Village of Lemont

VILLAGE BOARD COMMITTEE OF THE WHOLE MEETING
January 23, 2023 – 6:30 PM
Village Hall - Village Board Room
418 Main Street, Lemont, IL 60439
AGENDA

TO: Village Board Committee of the Whole Meeting
FROM: Jamie Tate, Community Development
THROUGH: Jason Berry, CEcD, AICP, Economic & Community Development Director
SUBJECT: A Discussion of Case 2021-04 Mary Ellen Woods
DATE: January 23, 2023

FINAL ENGINEERING PLANS
FOR
"MARY ELLEN WOODS"
3 W. ROBERTA STREET, LEMONT, ILLINOIS

MWRD - DRAINAGE EXHIBIT PLAN - I
MARY ELLEN WOODS
LEMONT, ILLINOIS

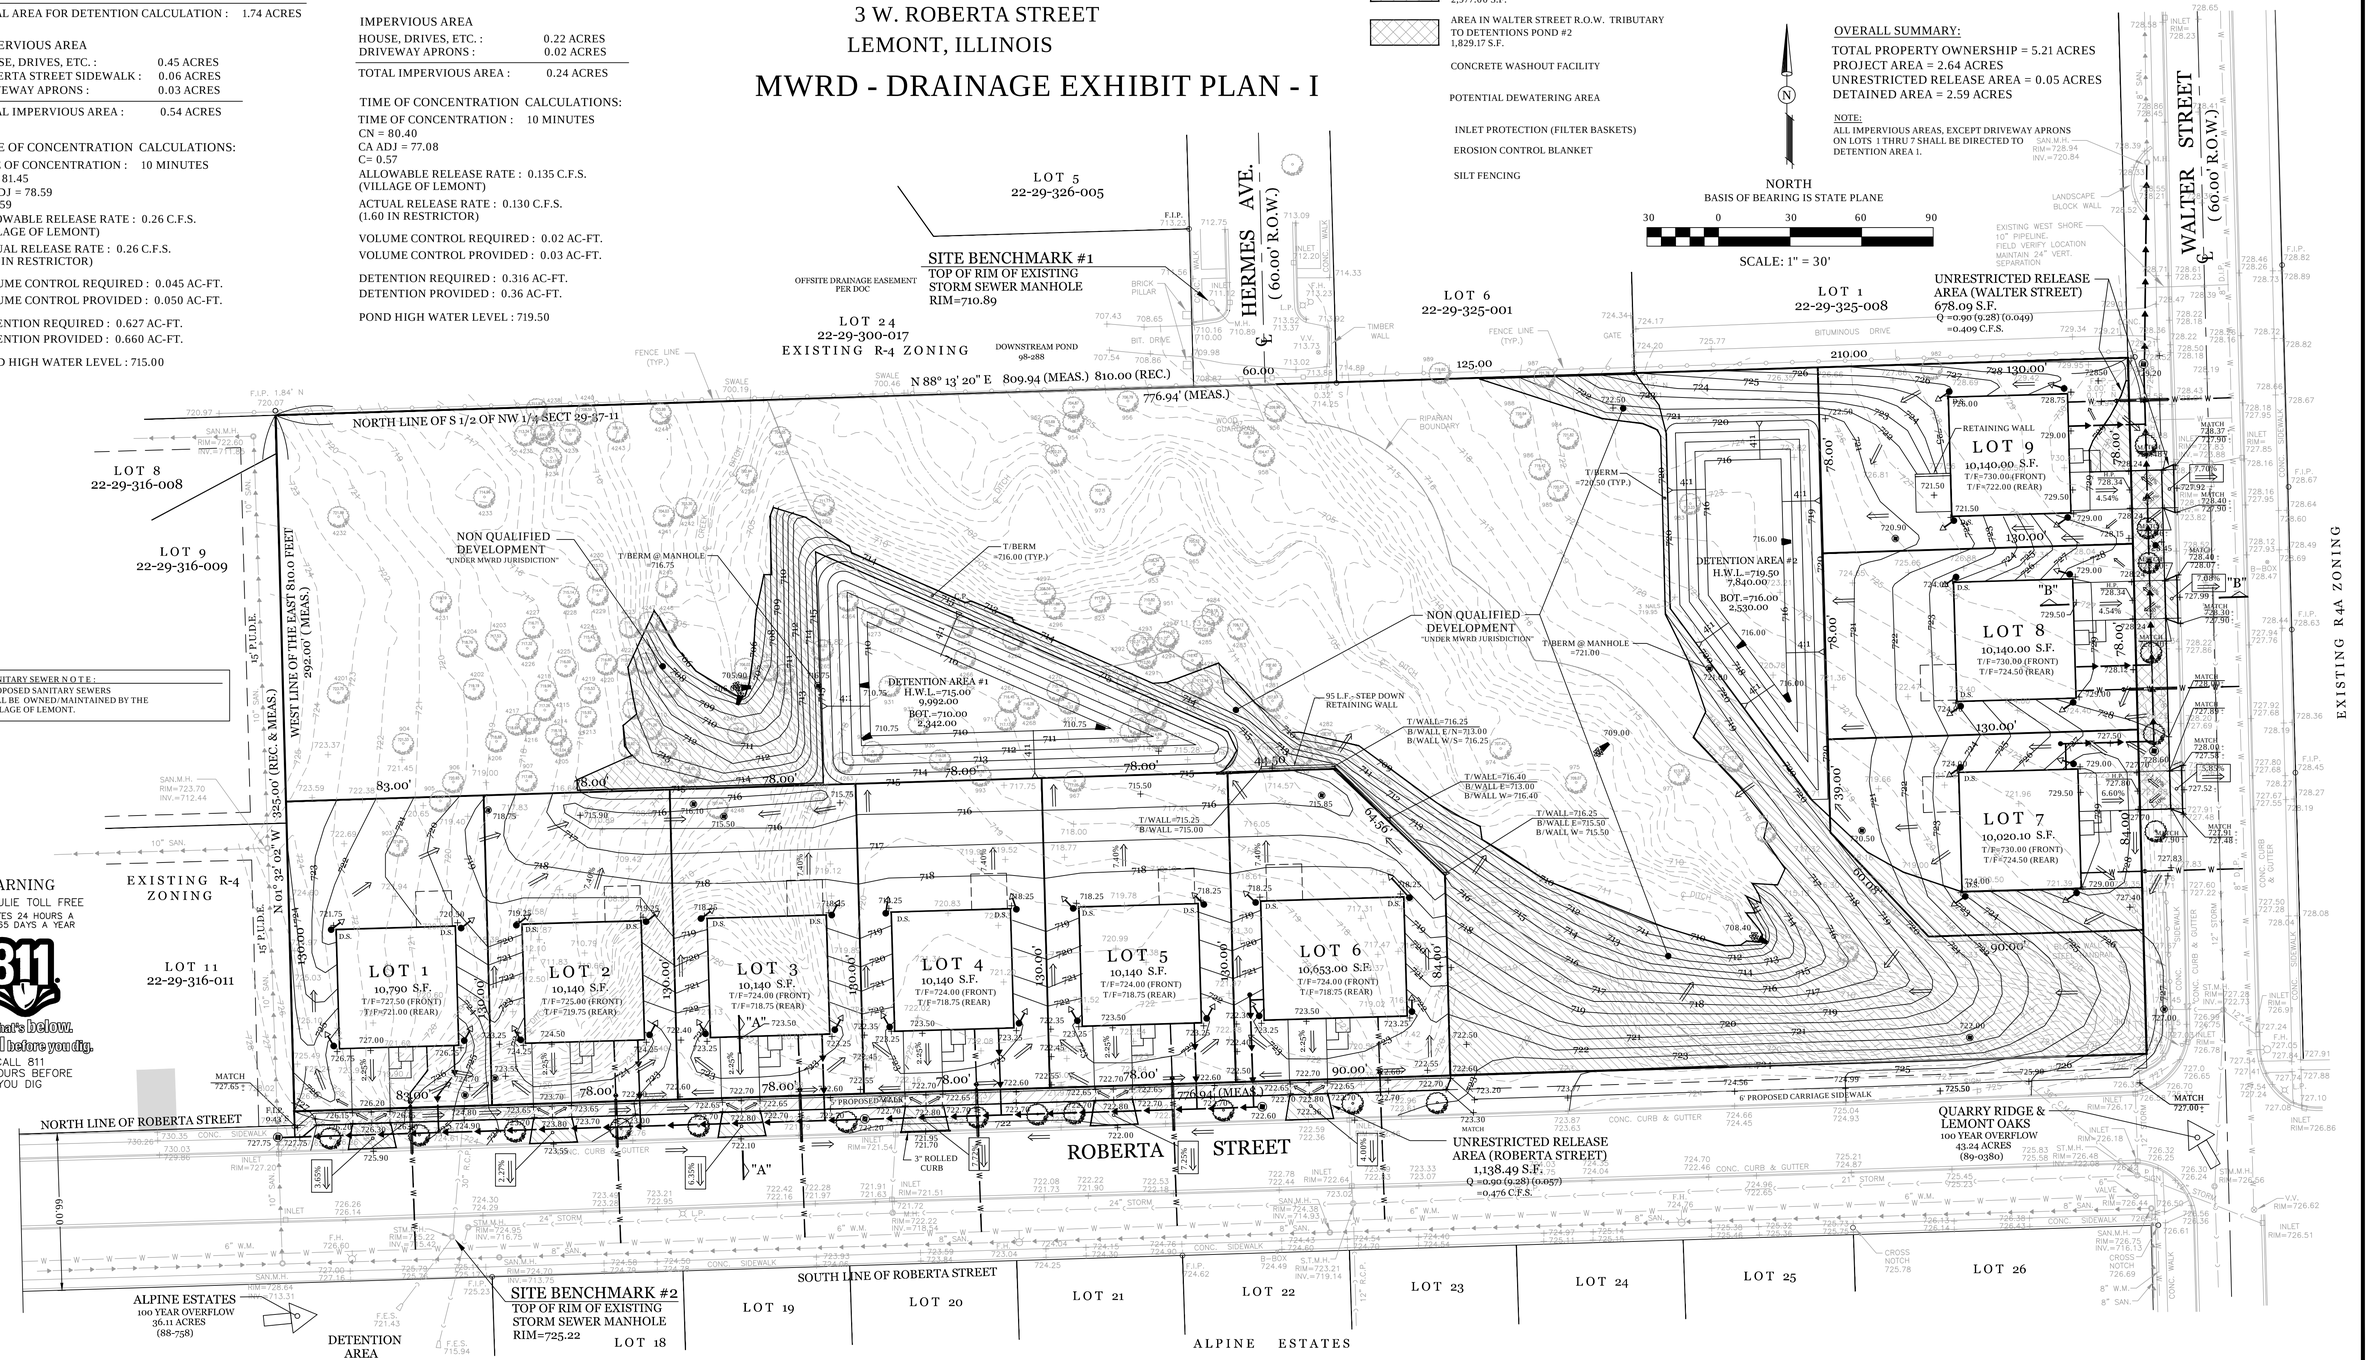
12. On Sheet 2, please explain to me what a Non-Qualified Development" area is. Is it Army Corp jurisdiction?
